Subject: COMMENT RESPONSE - Phase I Application for Hazardous Waste Landfill
No. 7
MAX Environmental Technologies, Inc. – Yukon Facility
South Huntingdon Township, Westmoreland County, Pennsylvania
CEC Project 170-822.2240
I.D. No. PAD004835146
APS No. 1071176
AUTH No. 1410078

**MAX ENVIRONMENTAL TECHNOLOGIES, INC.
RESPONSE TO TECHNICAL DEFICIENCY LETTER
DECEMBER 12, 2022**

REVISED EXHIBIT 9-2.1

Subject: Transmittal
Revised Wetland and Stream Delineation Report
Hazardous Waste Landfill No. 7
MAX Environmental Technologies, Inc. – Yukon Facility
South Huntingdon, Westmoreland County, Pennsylvania
Hazardous Waste Permit No. PAD004835146
CEC Project 170-822.1222

**HAZARDOUS WASTE MANAGEMENT FACILITY
PERMIT APPLICATION DRAWINGS
(1983)**

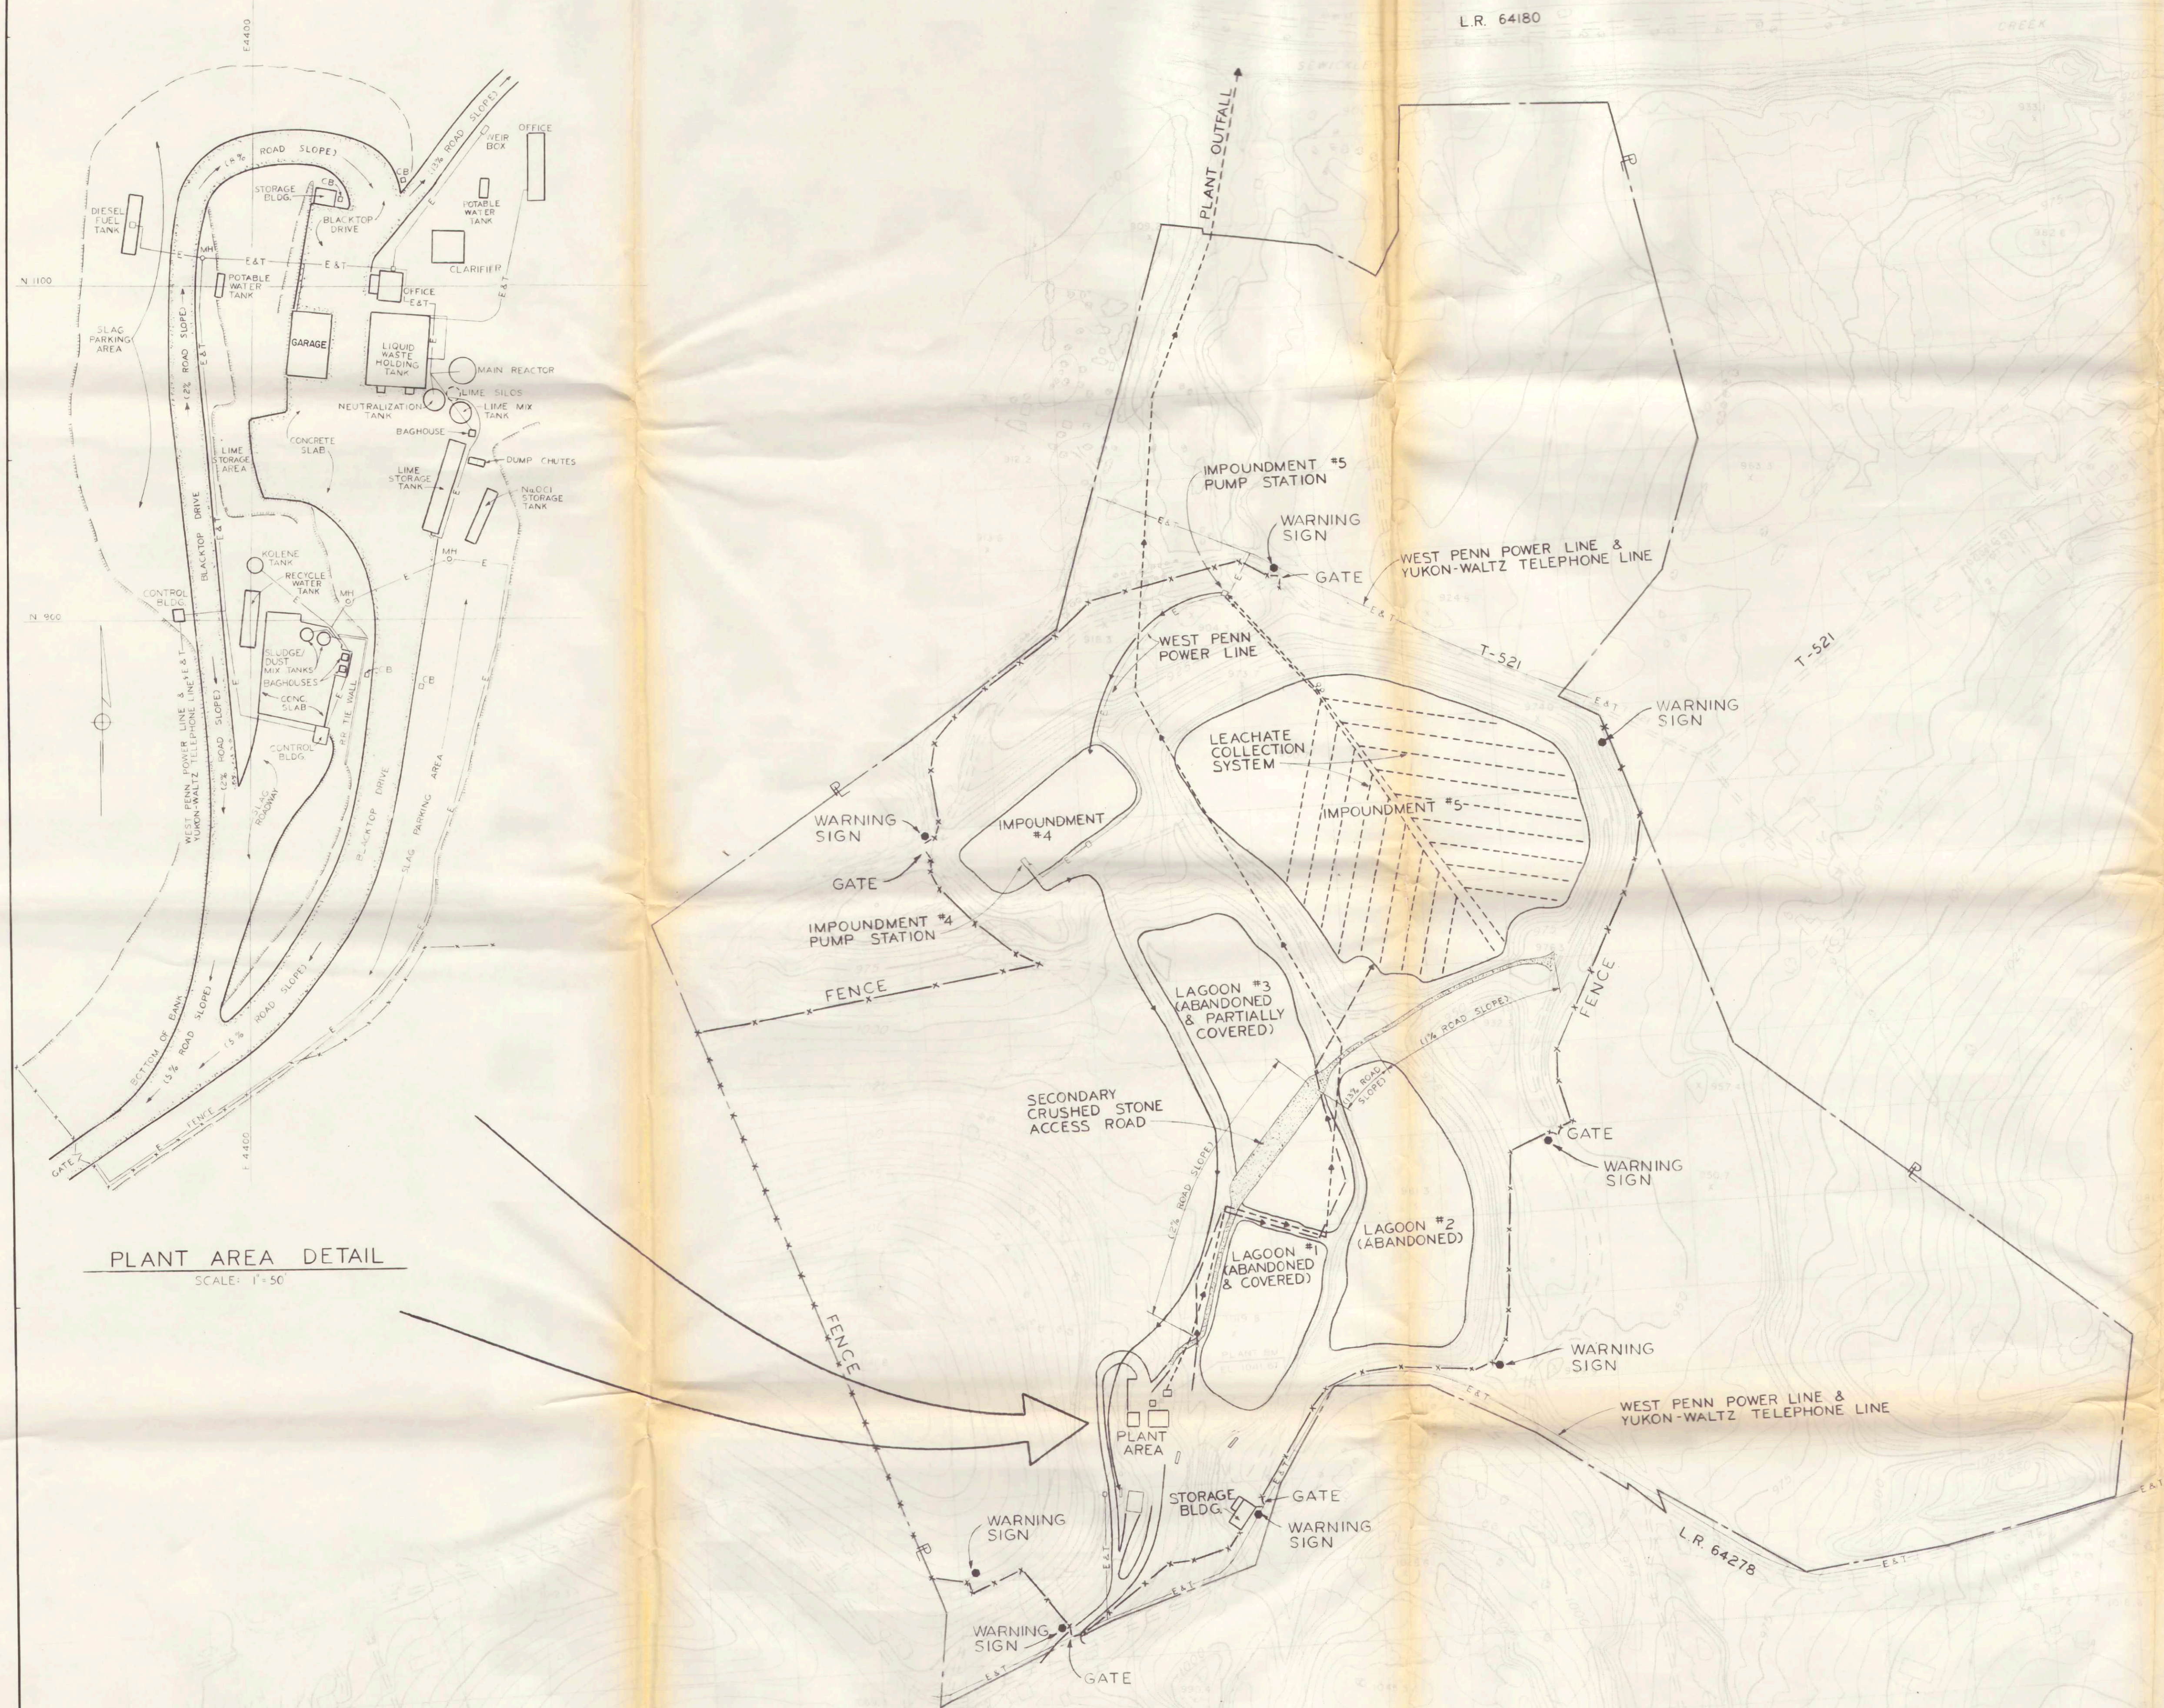
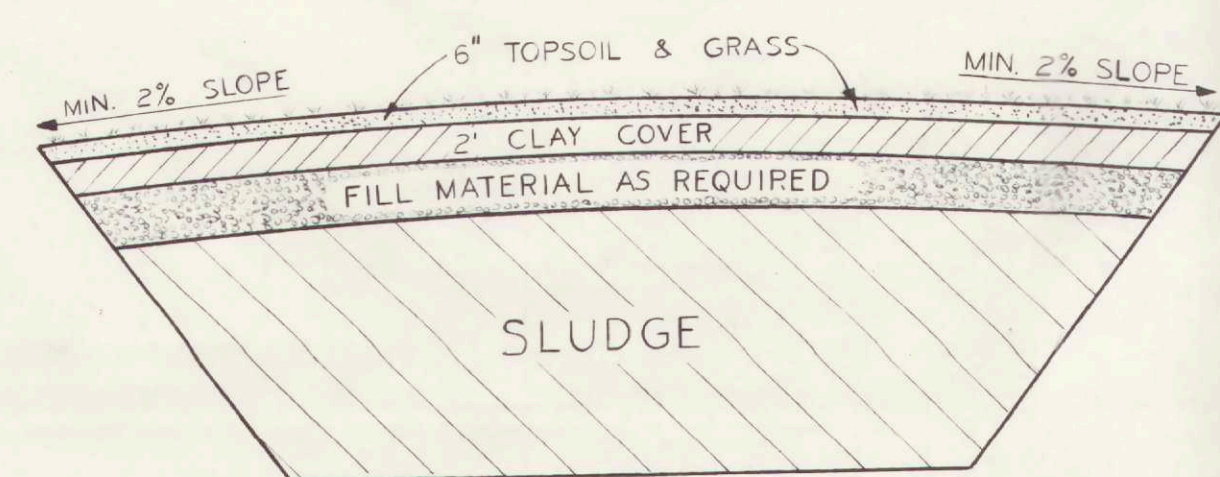
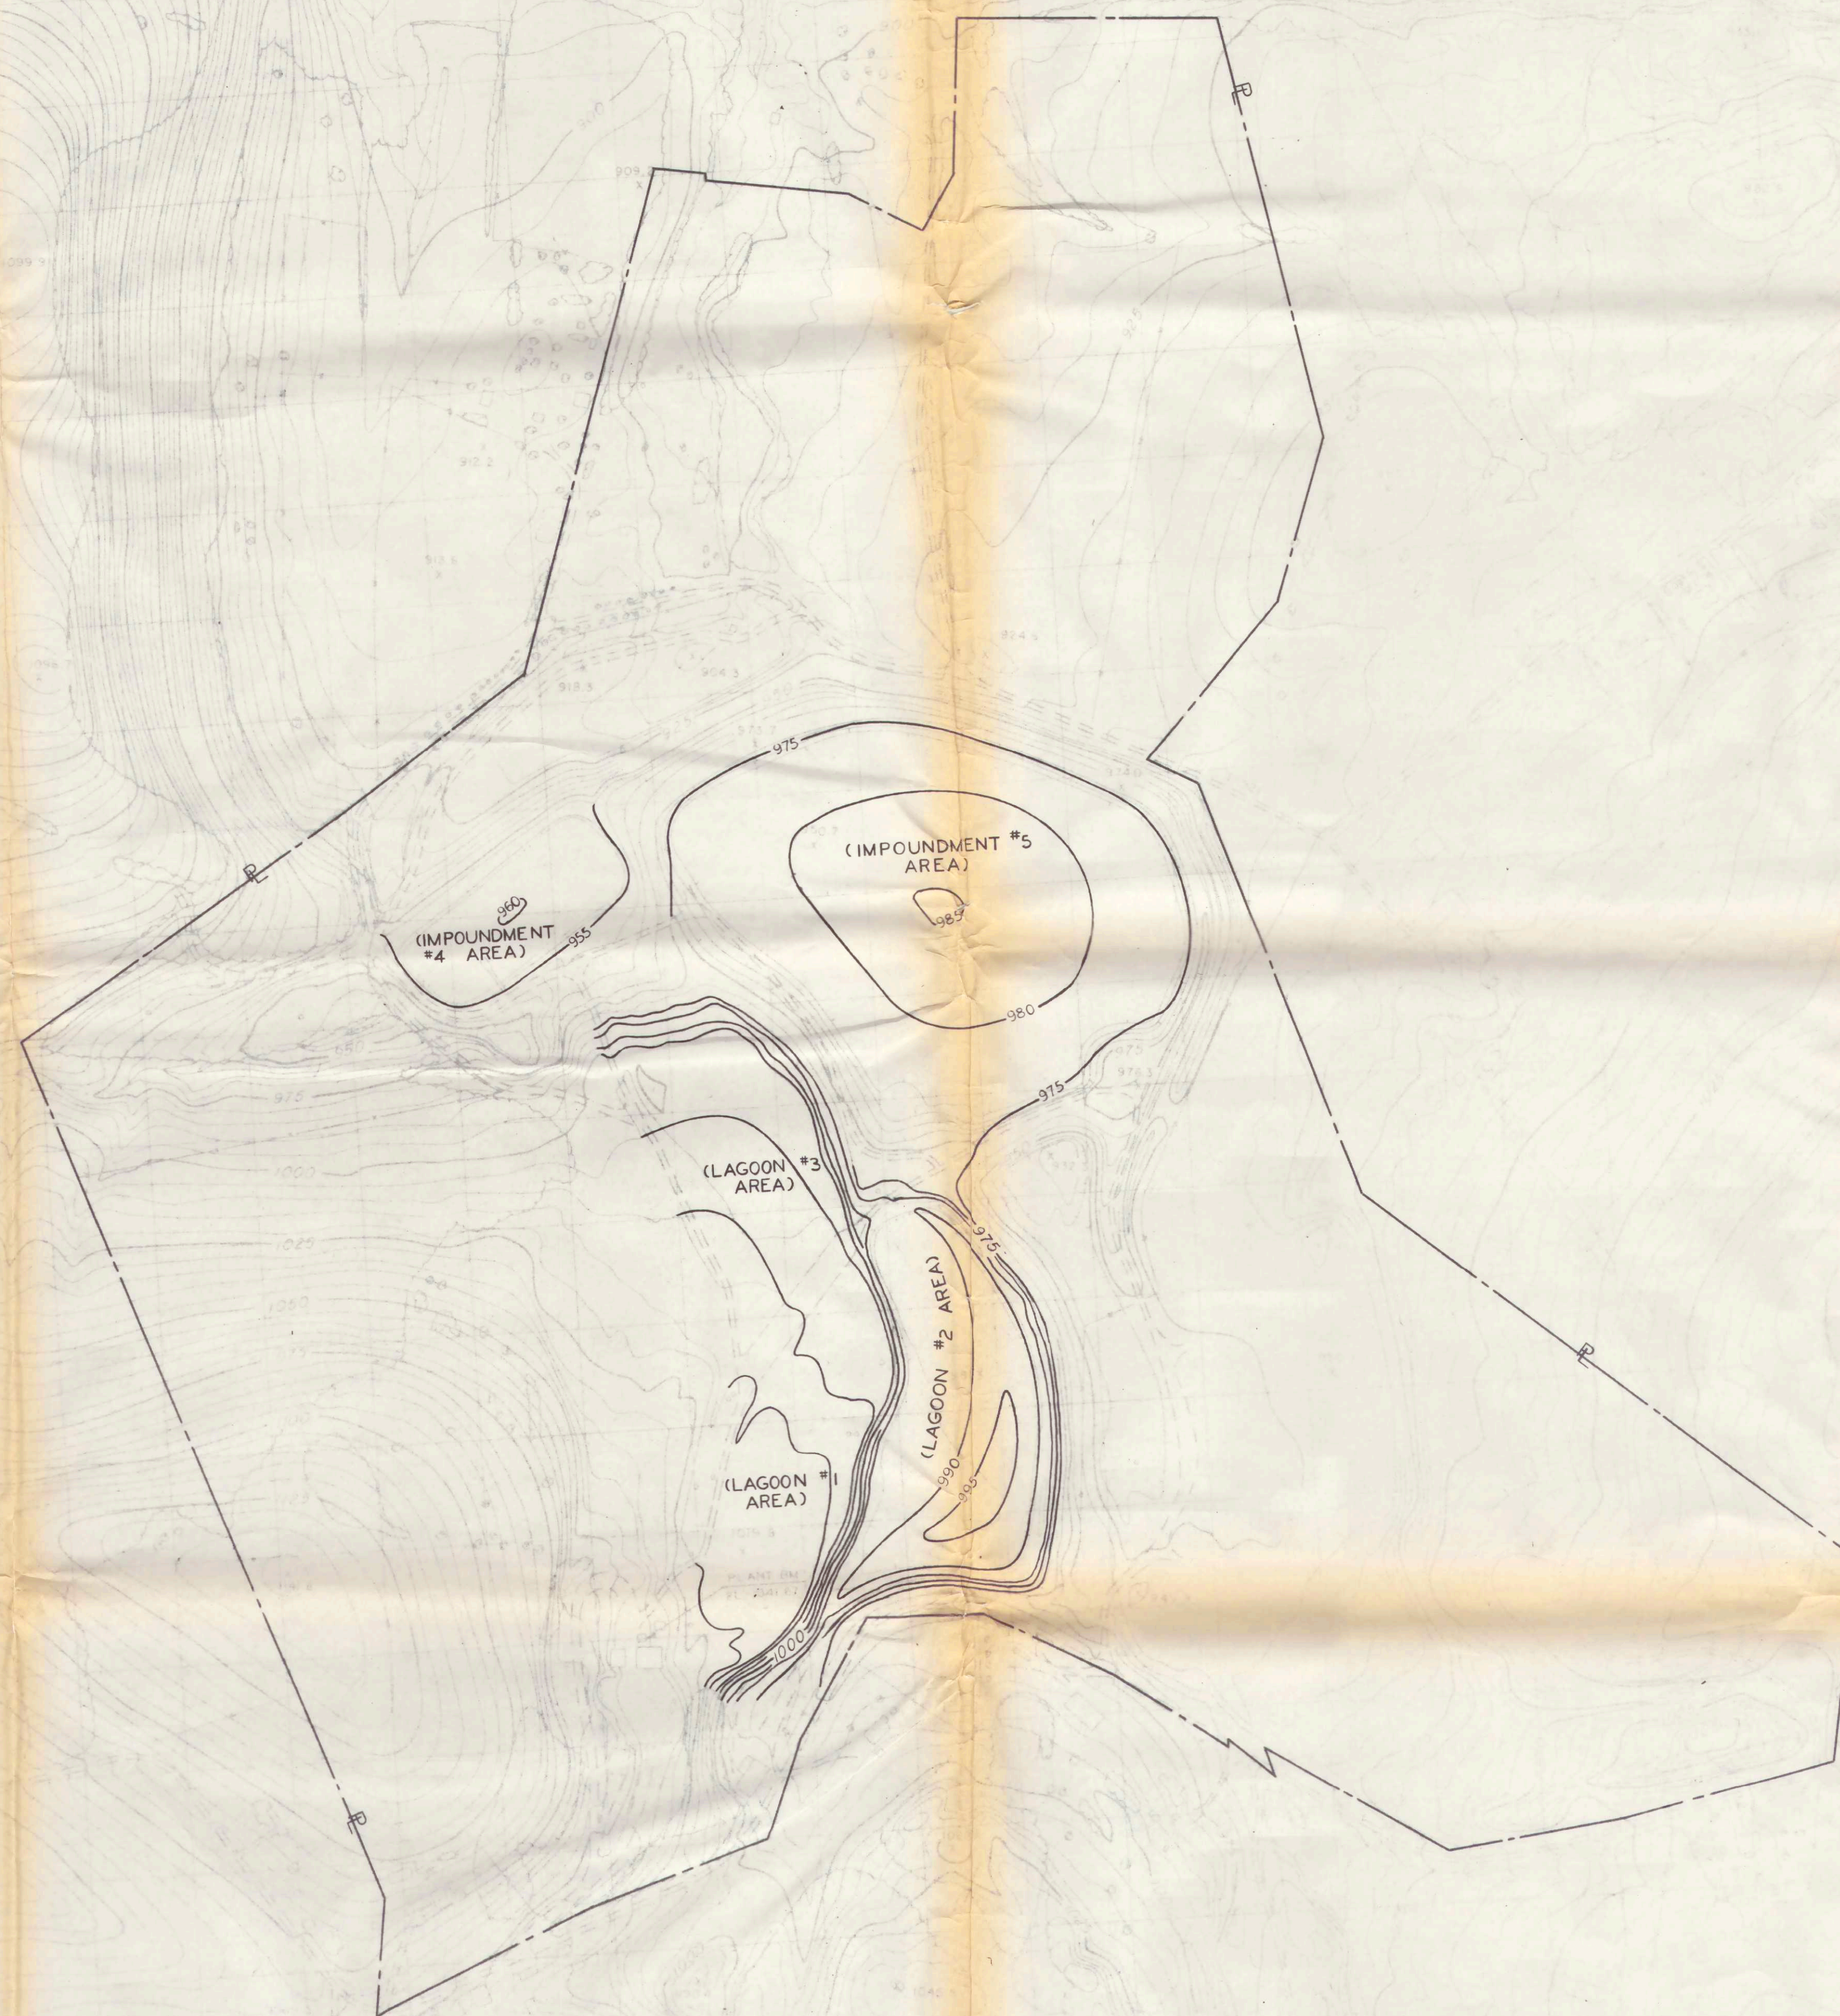
2. **25 Pa. Code § 269a.23 specifies that treatment and disposal facilities may not be sited in wetland areas. *Wetland* is defined in 25 Pa. Code § 269a.1 as “An area inundated or saturated by surface water or groundwater at a frequency and duration sufficient to support, and that under normal circumstances does support, a prevalence of vegetation typically adapted for life in saturated soil conditions, including swamps, marshes, bogs and similar areas. The term includes, but is not limited to, wetland areas listed in the State Water Plan, the United States Forest Service Wetlands Inventory of Pennsylvania, the Pennsylvania Coastal Zone Management Plan, the United States Fish and Wildlife National Wetland Inventory and wetland areas designated by a river basin commission.” As proposed, the facility site boundary includes wetland area north of the existing leachate storage tank within the proposed facility boundary. This wetland area is identified in the application in Exhibit 9.1.1, Figures 2 and 3 and Exhibit 9-2.9, Figure WDR-3A. Inclusion of this wetland within the facility site boundary violates 25 Pa. Code § 269a.23 and cannot be approved. Furthermore, delineation of potential wetland areas at the site is incomplete and additional delineation studies that were committed to by Max in 2019 email correspondence with DEP and the US Army Corps of Engineers have not been completed. [See Attachment 1]**

RESPONSE: On October 31, 2022, CEC and MAX submitted an Application Amendment that provided a revised “Area Not Subject to Phase 1 Exclusionary Criteria Review.” Previously, the existing facility site boundary was incorrectly delineated. This was discovered after reviewing older permit application files for MAX's existing hazardous waste permit. As seen in those documents, it appears the previously permitted facility boundary appears to be concurrent with the property boundary for Parcel 59-04-00-0-004 [see previous submissions; the drawings are also included again with this submittal (see Attachment 3)].

CEC and MAX acknowledge that this previously permitted facility boundary includes Millbell Road, as well as areas to the south and north of Millbell Road. The area to the north of Millbell Road includes the proposed Hazardous Waste Landfill No. 7 area. The area to the south of Millbell Road includes the existing hazardous waste operations.

As discussed previously with the DEP, areas included in the new hazardous waste permit boundary, but fall within the existing permitted facility boundary, are not subject to Phase I Exclusionary Criteria Review. However, MAX/CEC are not requesting that this entire area falling within this previously permitted facility boundary be excluded from Phase I Exclusionary Criteria Review. Rather, areas to the north of Millbell Road, which may have been included in the previously permitted facility boundary, but were never subject to hazardous waste activities, are not included in the “Area excluded from Phase I Exclusionary Criteria Review.” Instead, MAX is proposing that only areas to the south of Millbell Road be included in the “Area excluded from Phase I Exclusionary Criteria Review”, due to

existing permitted hazardous waste operations extending to the south side of Millbell Road (i.e., Pump Station No. 5, a unit which is included in MAX's hazardous waste storage and treatment permit). Therefore, any area to the south of Millbell Road that is within a previously permitted facility boundary and has been subject to ongoing permitted hazardous waste activities for a number of years should be included in the "Area excluded from Phase I Exclusionary Criteria Review." We are resubmitting the pertinent reference drawings (see Attachment 3), reflecting this more accurate delineation of the existing permitted facility site boundary, including the site drawing from MAX's 2014 hazardous waste storage and treatment permit renewal application (which we understand is still under review by DEP).
